Docket Nos. ~~50~~-269  
and 50-270

Change No. 9 License No. DPR-38  
Change No. 4 License No. DPR-47

Your letter of December 19, 1973 requested that Technical Specification 6.1, Appendix A to License No. DPR-38 and No. DPR-47 be revised to include a Maintenance Engineer who will report to the Station Superintendent and to modify the membership of the Station Review Committee. We find that there is reasonable assurance that the health and safety of the public will not be endangered by this change.

OCONEE NUCLEAR STATION  
STATION ORGANIZATION CHART  
FIGURE 6.1-1

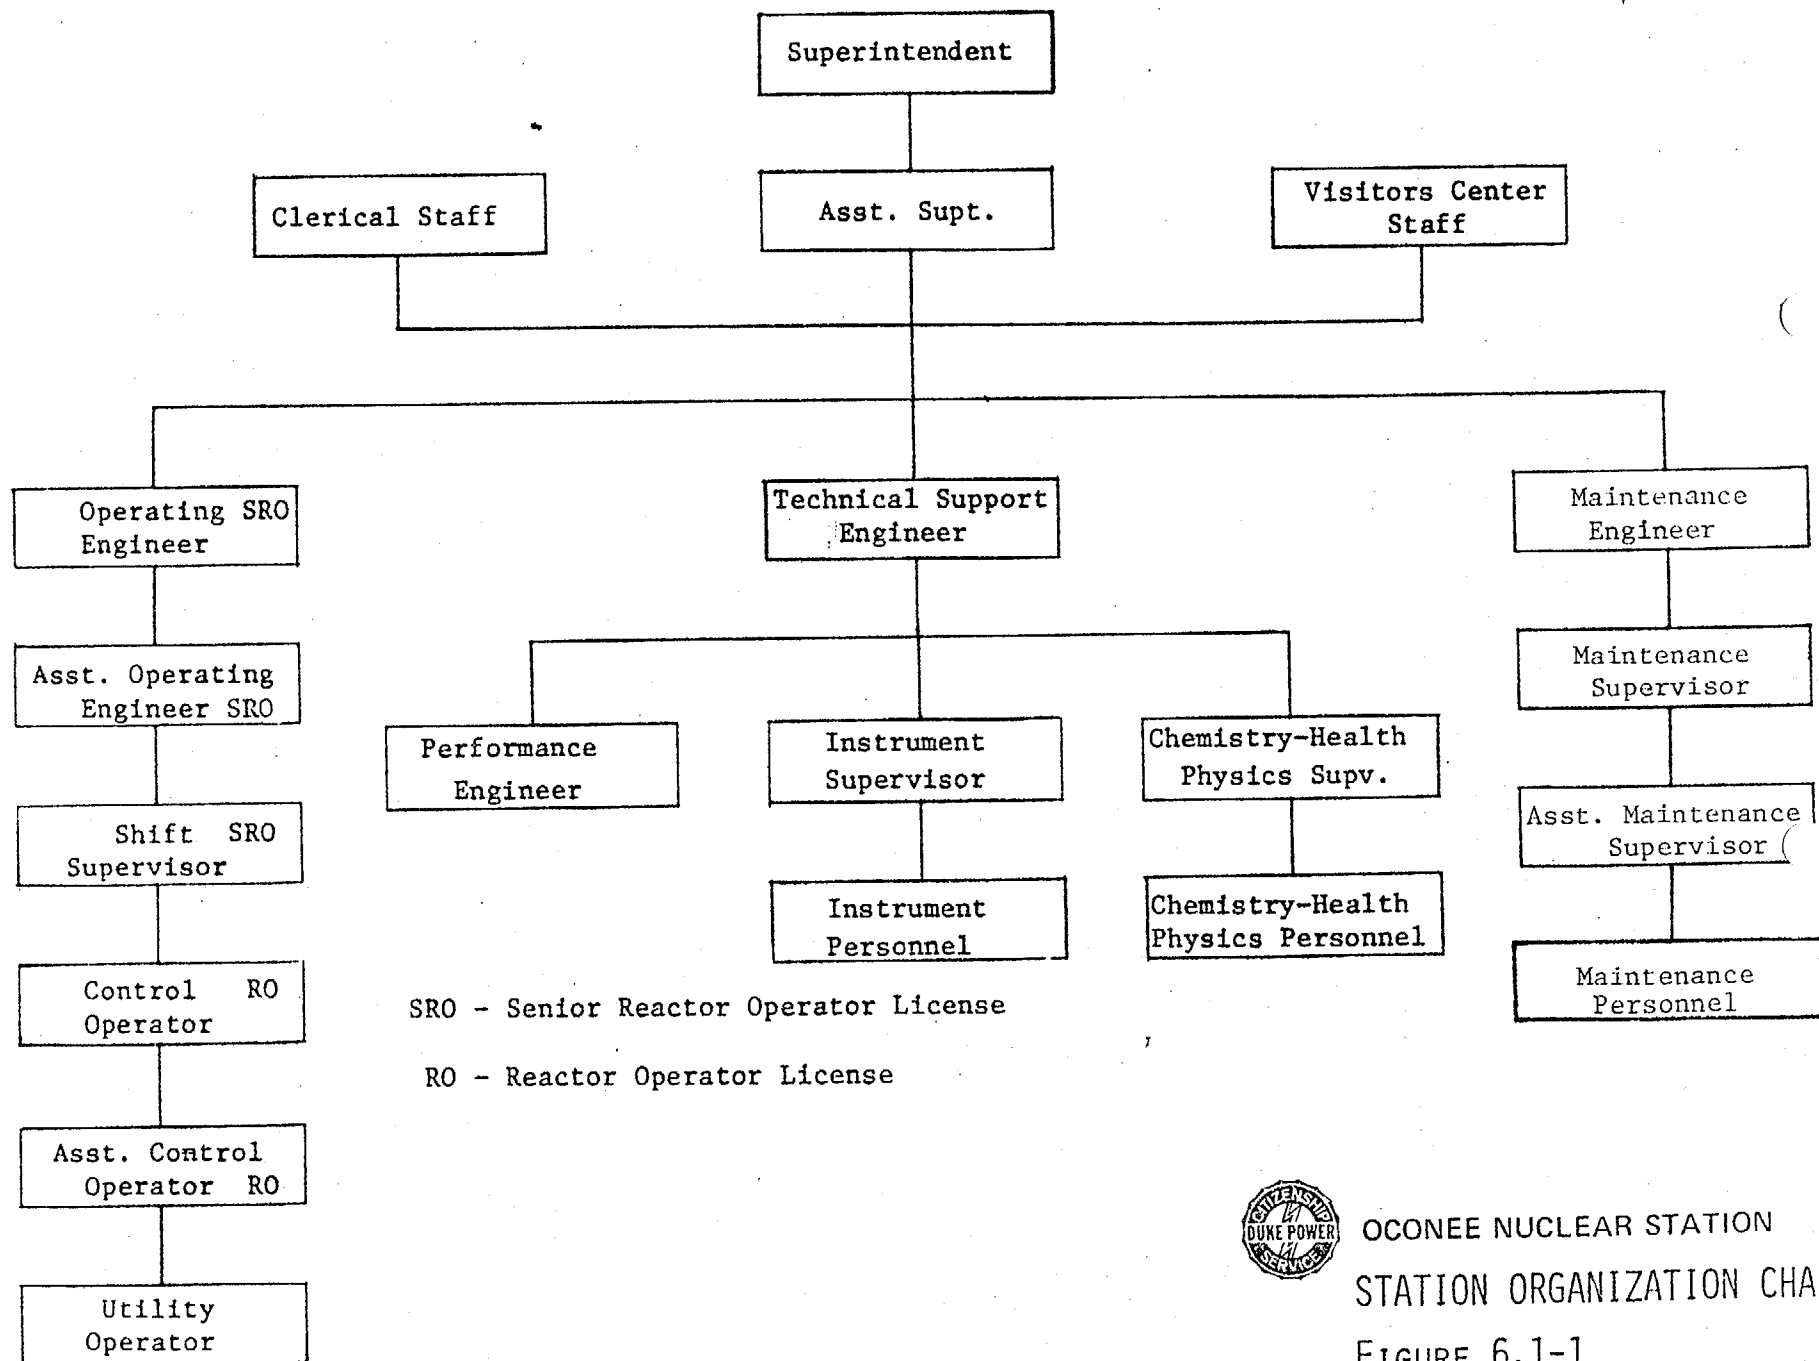
Pursuant to Section 50.59 of 10 CFR Part 50, Technical Specifications, Appendix A to License Nos. DPR-38 and DPR-47, have been changed in accordance with the revised Technical Specifications 6.1 enclosed. These changes are identified as Change No. 9 to Technical Specifications License DPR-38 and Change No. 4 to Technical Specifications License DPR-47 and are effective on the date of issuance.
